Enclosure 1 to
LTR-RAC-20-94
Date: December 18, 2020

Response to Request for Additional Information

Environmental Review for the Proposed Renewal of the
Westinghouse Columbia Fuel Fabrication Facility License

Figure RAI 6-1: Map of CFFF Intermodal Containers & Soil Remediation Locations

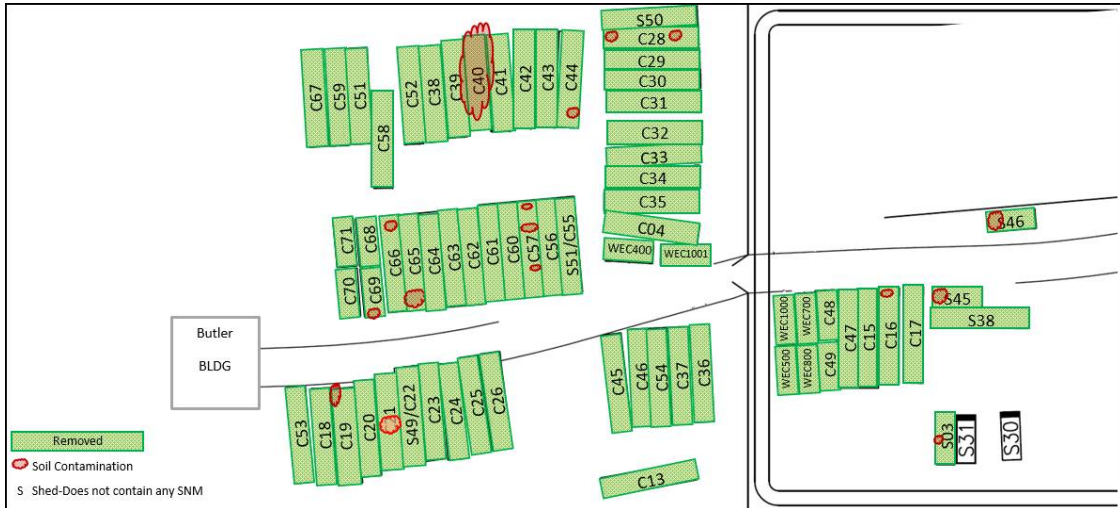
In November 2019, Westinghouse submitted a work plan to SC DHEC to complete the risk-based investigation of intermodal storage within the Southern Storage Area Operable Unit in follow-up to a May 2019 inspection that discovered a hole in the roof of the storage container holding drums of combustible materials containing uranium. Rainwater penetrated the roof of the containers and compromised the flooring and the drum lids. Westinghouse sampled the water found within the storage containers and the soil underneath those containers. In its comments on the draft EA, Westinghouse clarified that the affected soil was remediated, and reports describing the progress on the removal of the intermodal containers have been submitted to SC DHEC. Please provide the following information:

- A. Provide an update of the intermodal container removal activities, soil sampling results, and removal and disposal of contaminated soil.
- B. Discuss the facilities and methods that will be used to manage uranium-containing material currently stored in intermodal storage (i.e., storage, treatment and disposal) during the proposed 40 years of operation.

- A. In May 2019, several intermodal containers which contained uranium-bearing materials were determined to be in poor condition. In response to this condition, Westinghouse developed an accelerated, risk-based approach for clearing the Southern Storage Area (SSA) In total, sixty-two intermodal containers in the SSA Operable Unit OU designated as containing uranium-bearing materials were identified for removal and accelerated processing (including the initial intermodal container, C-40). Westinghouse achieved this goal in November 2020, several months ahead of schedule.

Due to the large size of the laboratory reports for the 62 intermodal containers, Westinghouse has provided Figure RAI 6-1 and Enclosure 10 the Sum of Fractions (SoF) of Isotopic Uranium in Soil Beneath Sea-Land Containers Figures, depicting the areas where uranium contaminated soil was removed at depths ranging from six inches to a few feet. This remediation removed shallow impacted soil to prevent future groundwater impact. Only the uranium values are listed on the figures as results for Tc-99, F, and PCE (with the exception of one area underneath intermodal container C-21) were below the residential screening values described in procedure RA-433, "Environmental Remediation" (Enclosure 11). Any impacted soil underneath the intermodal containers has been remediated as necessary per RA-433 to below the residential screening levels (RSL) for uranium. Impacted soil was or is being transported to an approved low level radioactive waste (LLRW) disposal site.

items such as maintenance equipment and spare parts. To date, 10 intermodal containers have been removed and two other intermodal containers have been emptied and repurposed to support the site's Emergency Response Organization.
